Re: Comments on NIPSCO's 2021 Integrated Resource Plan

**Report on Northern Indiana Public Service Company's 2021 IRP  
Submitted to the IURC on March 24, 2022**

**On behalf of Citizens Action Coalition of Indiana,  
Earthjustice, and Vote Solar**

**Figure 1. Generic Solar Cost Comparison (\$/kW)<sup>8</sup>**

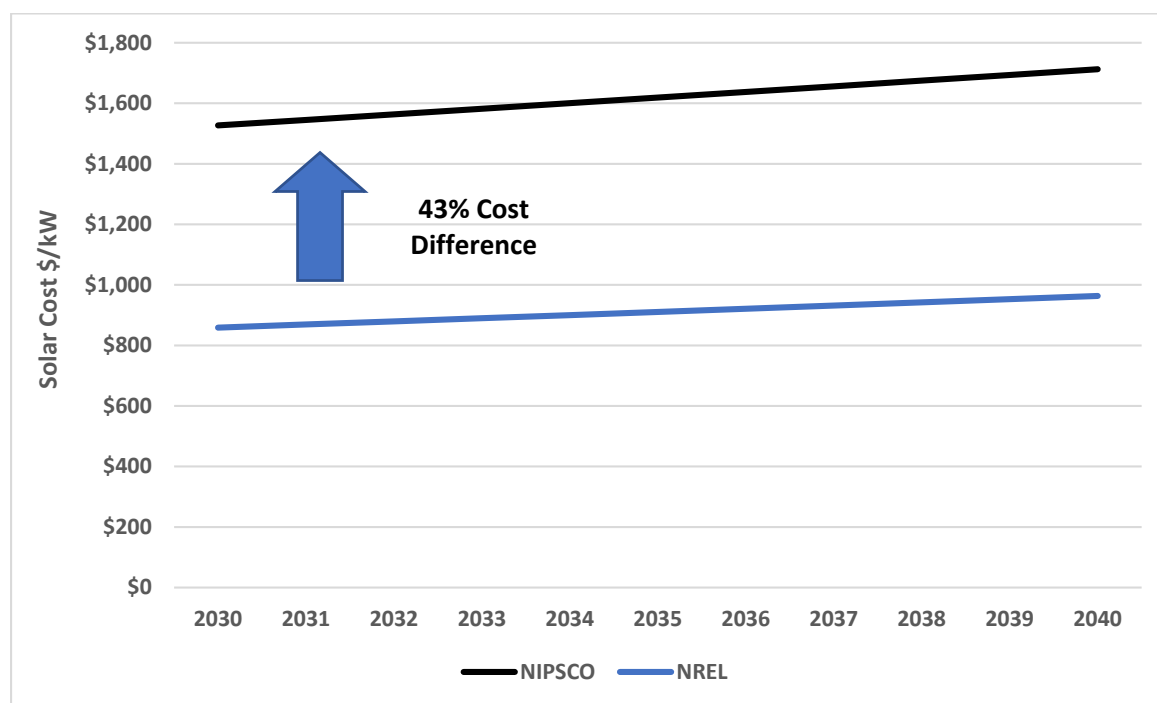
NIPSCO included the RFP tranches to represent the RFP bids and then allowed the model to select generic renewable and storage resources starting in 2030. Our review of the generic solar costs indicates that NIPSCO is overestimating the costs of these resources, apparently stemming from inflationary concerns that occurred with projects due to supply chain issues. In response to CAC Informal Discovery Request 1-009, NIPSCO said:

Figure 1 shows the comparison of NIPSCO’s generic resource cost compared to the NREL’s 2021 ATB for solar resources. The cost difference between NIPSCO’s solar assumption and the 2021 ATB solar costs is about 43%. We understand that the global pandemic has led to supply chain issues and inflationary pressures, but NIPSCO’s costs assumptions seem to single out solar projects exclusively. We are concerned that this inflationary pressure is being applied in a discriminatory fashion if it is not being equitable applied to all resource types. For instance, inflation in the labor market would apply to any project regardless of whether it is a renewable, storage, or thermal project.

In addition, the long-term impact of the current supply chain and inflationary costs are unknown, especially if one is looking at projects implemented in the late 2020s and early 2030s. If these cost increases do continue to persist into the late 2020s and 2030s timeframe, then cost increases need to be evaluated across all resource types and not just one technology.

**Figure 2. Ancillary Service Value \$/kW-Year<sup>10</sup>**

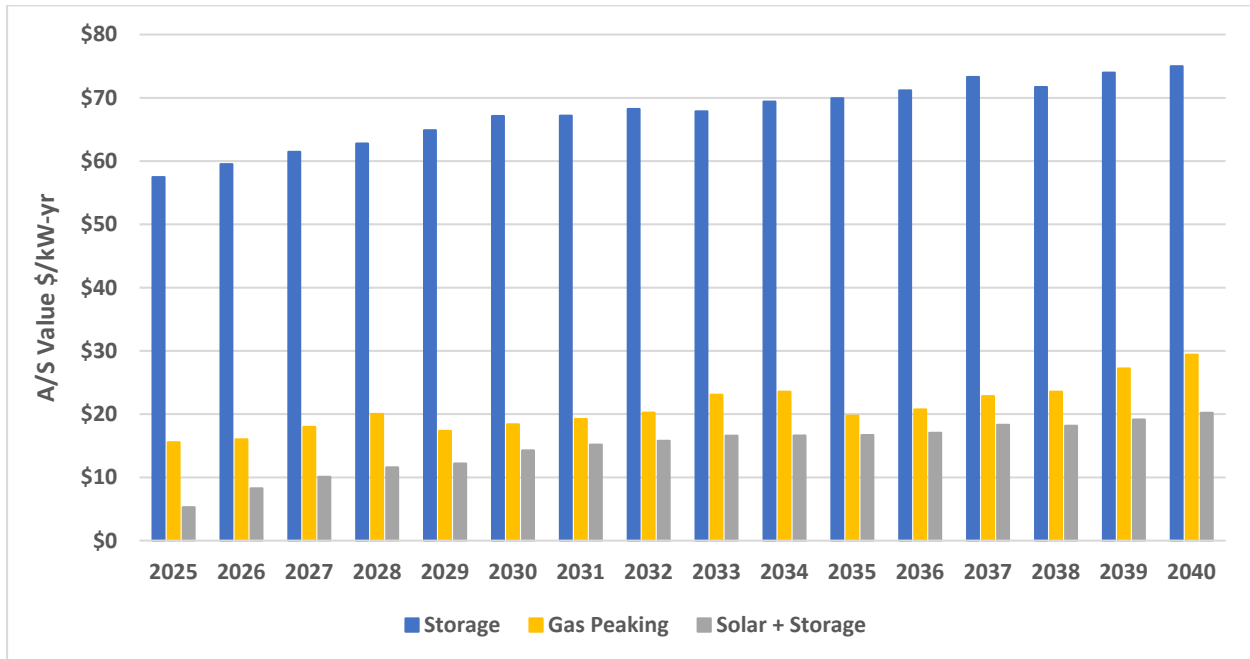
Having separate markets helps to release constraints on modern resources, providing benefits in several forms. When MISO eventually adopts this practice, the value of the renewable heavy portfolios, as shown for example in the center graph of IRP Figure 9-31 and the opportunity bars of Figure 9-34, will increase. Both wind and solar provide an extremely high quality regulation service. Field demonstrations, for example, in California ISO with both wind and solar PV plants<sup>49</sup> showed that the quality of the regulation response from wind and solar PV was measurably superior to thermal generation. Operating expectation (and FERC’s expectation) is that superior regulation performance should result in reduced amounts of regulation being procured, resulting in operating cost savings for all stakeholders. FERC requires that superior performance be rewarded with accompanying market signals.

**Figure 4. NIPSCO Replacement Portfolios<sup>32</sup>**

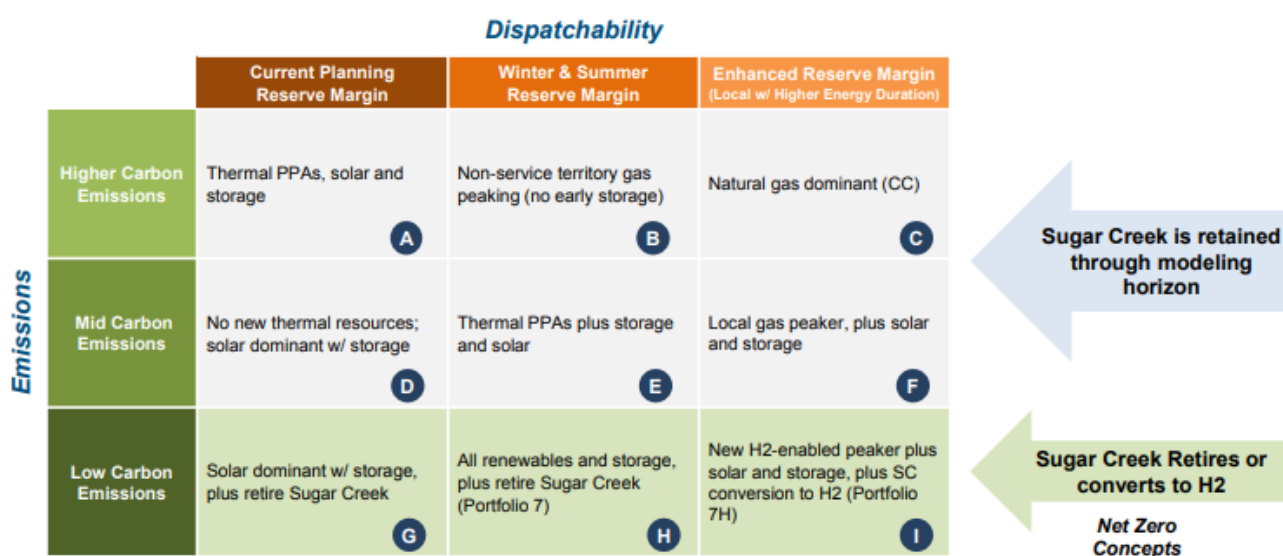
Figure 4 below shows the nine replacement portfolios that NIPSCO modeled across the dispatchability and emissions concepts.

Portfolio I is 3.10% more expensive on a PVRR basis when compared to Portfolio E, which relies on battery storage in place of a thermal or hydrogen enabled peaker plant. In addition to the increased cost from Portfolio I, there are also risks around the difficulties of commercializing hydrogen technology at this level and a question of whether or not the peaker will be able to
